12765 ENT WITHOUT A PERMIT 4021 Island Dr Lot 15G Oar St

Subject: Re: § 10.02.01 DEVELOPMENT WITHOUT A PERMIT 4021 Island Dr Lot 15G Oar St

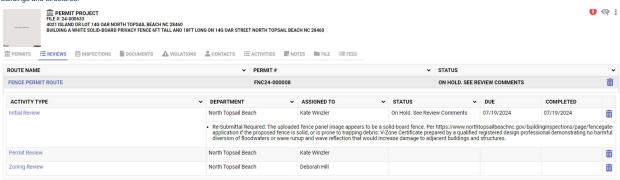
I already called several engineers to ask for a V-zone certification. In the alternative, I submitted a picture of a white vinyl shadowbox fence.
